CABINET MEMBER FOR ENVIRONMENT – 19 DECEMBER 2019

OXFORD / NORTH HINKSEY: BOTLEY ROAD & WEST WAY - TRAFFIC MEASURES

Report by the Interim Director for Community Operations

**Statutory Consultation Drawings
(Sheet 1 of 5) ANNEX 1**

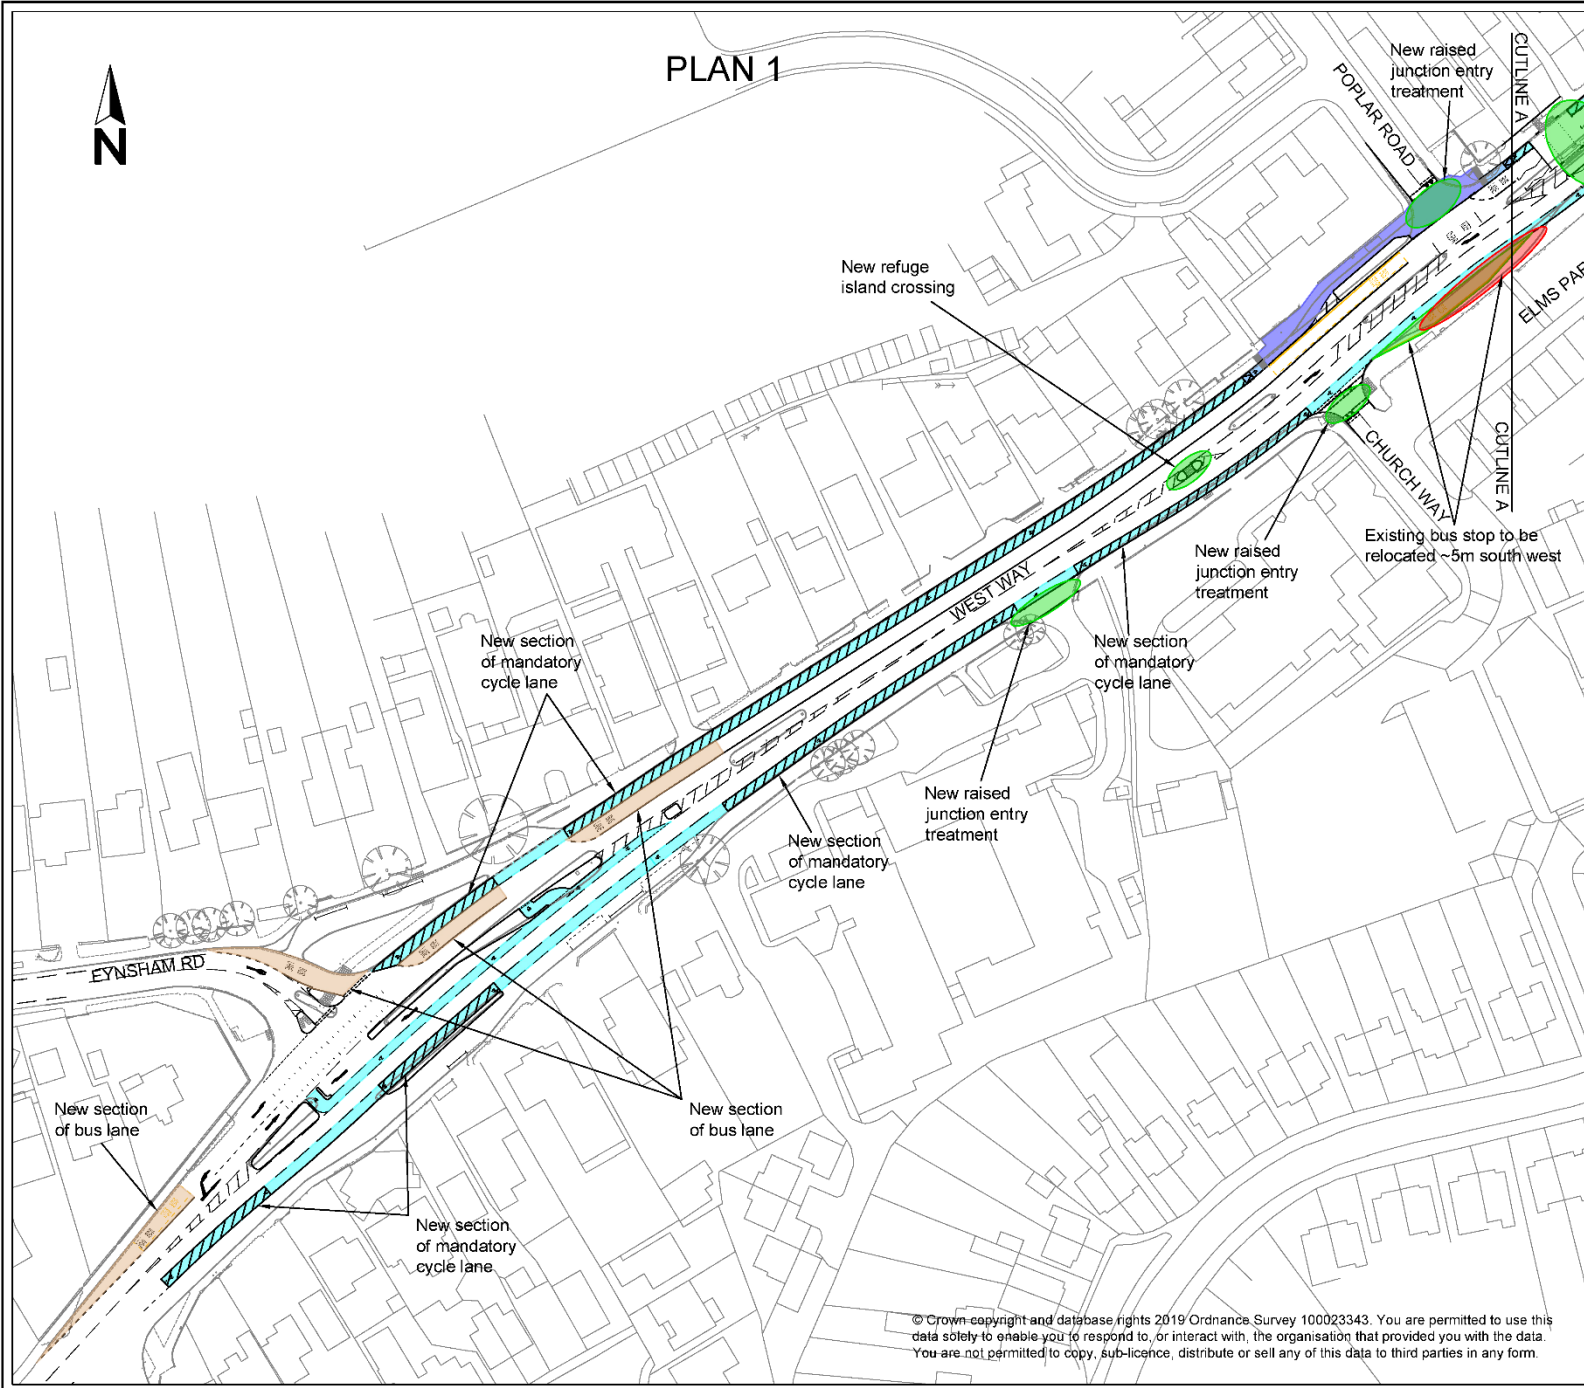
<p>(91) Local Resident, (Oxford, Cope Close)</p>	<p>Object</p>	<p>Plan 1 of 5 Support the extension of the bus lane on the northwest side of West Way.</p> <p>Plan 2 of 5 Why is the pelican crossing outside Elms Parade being converted back to a staggered crossing? The developer of the West Way Shopping Centre has only in the past few months completed the conversion from a staggered crossing to a straight across one. If this is being converted back to reduce delays to traffic why did the County give permission for the change?</p> <p>I note the minor change to the kerb line on the south side of West Way to move the cycle facility onto the carriageway. There are no other changes being proposed and I cannot see therefore how any extra capacity will be created at the West Way/Westminster Way junction to cater for the increased traffic from the West Way Shopping Centre development. Can you confirm that there is increased capacity and if so how it is being achieved?</p> <p>I object to the extension of the bus lane on the north side of West Way that will join the two sections either side of the Seacourt access road. Traffic going ahead at the A420 Slip Road/West Way junction will during heavy traffic periods tail back to the access to the retail park and often beyond it. At this point there is just the one general traffic lane and the bus lane. Traffic wishing to turn left at the traffic signals is trapped in this queue and adds to the general congestion. If the bus lane were to be shortened to the point where three lanes can be accommodated, i.e. two general traffic lanes and a bus lane, left turning traffic could get to the junction quicker and thus reduce queue lengths and the pollution emitted from stationary traffic. The bus lane itself is never occupied by more than four buses and this alteration would not restrict bus access to the remaining bus lane. With the current layout drivers wishing to turn left at the traffic signals are faced with the option of sitting in the queue or by-passing it by either entering the bus lane for a short distance or driving through the retail park. The additional queue lengths, that the current layout generate, affect the ability of traffic exiting Westminster Way to access West Way.</p> <p>I am still unclear as to why the kerb line on the northwest corner of the A420 Slip Road/West Way junction is shown as being altered. Traffic permitted to use this lane was at one time only permitted to proceed ahead. Has this restriction been removed?</p> <p>The approach to the A420 Slip Road/West Way junction replicates the present situation. Currently, during heavy traffic periods, drivers wishing to turn right into North Hinksey Lane will overtake the queue of traffic that is in the ahead lane by driving in the westbound lane. This results in conflicts with vehicles turning out of North Hinksey Lane or travelling westward from the traffic signals. I strongly recommend, in my letter of 25</p>

Title
Statutory Consultation Drawings (Sheet 3 of 5)

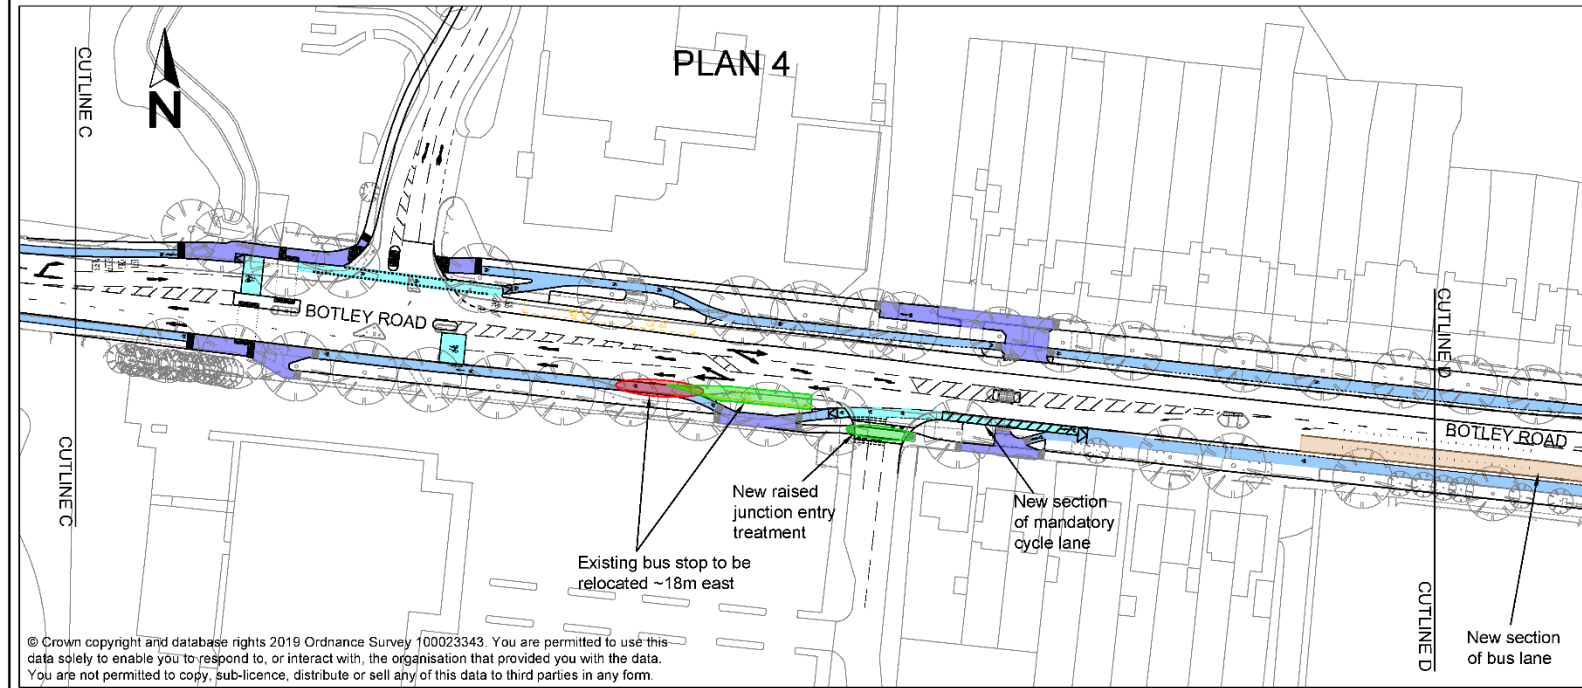
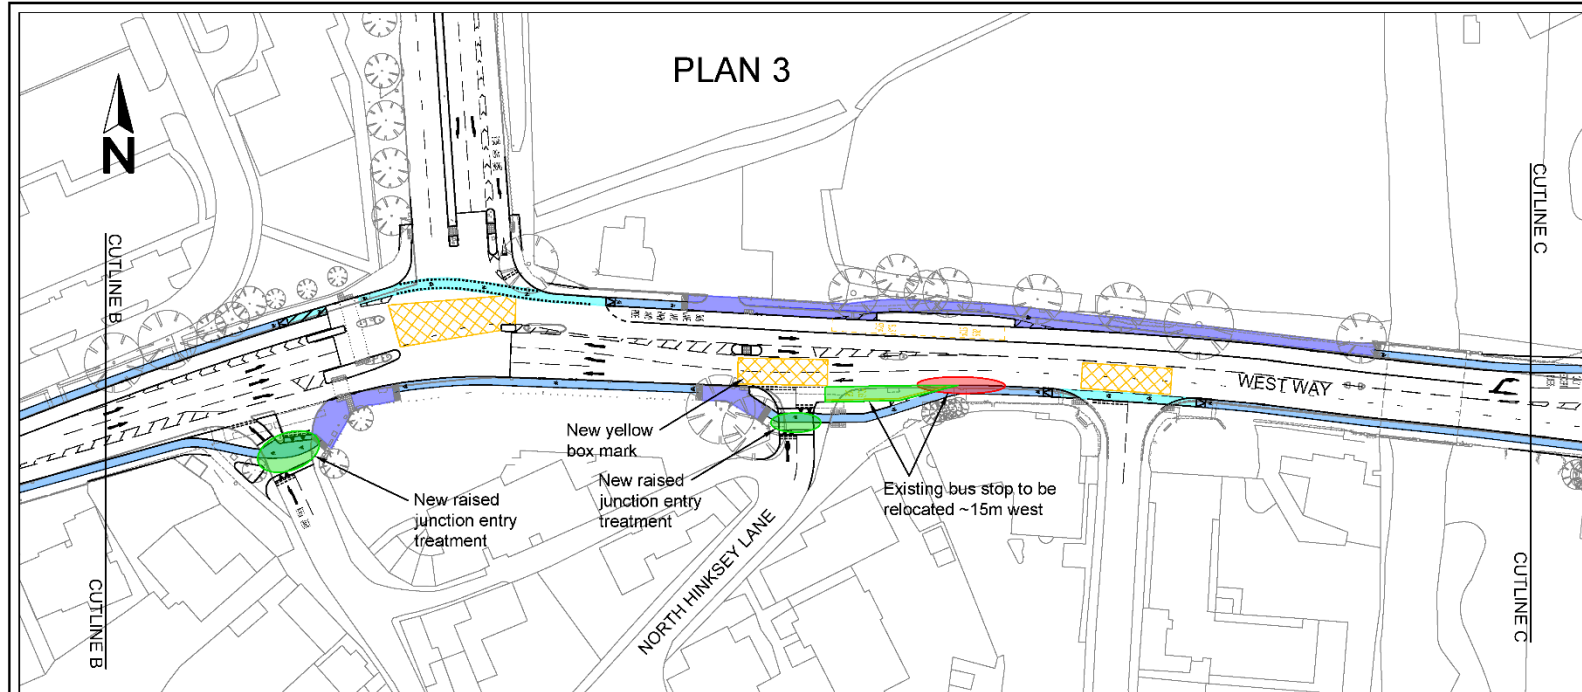
<p>June, that a small traffic island be installed within the hatched area to prevent this overtaking movement. Has this been considered and if so what reason was it discounted?</p> <p>Plan 3 of 5 Why does the yellow box marking only protect the A420 Slip Road/West Way junction inbound? During heavy traffic periods queues for the West Way/Westminster Way junction tail back into this junction which can have a knock on effect for traffic turning right from the slip road. This queuing is likely to become more frequent once the development of the West Way shopping area is complete.</p> <p>Plan 4 of 5 I object to the removal of the bus stop outside Waitrose. Bus passengers going to or from Waitrose using this stop have an access from the rear of footway, by the bus stop, into Waitrose. With the relocation those passengers will need to cross the traffic entering and exiting Waitrose. This is an unnecessary increase in risk for those pedestrians.</p> <p>Plan 5 of 5 What is the logic behind moving the bus stop on the north side of the road further west? It looks as though the entry taper to the bus stop affects the entry/exit to the West Oxford Community Centre. At times when more than one bus stops at the stop the entry/exit will be blocked.</p>
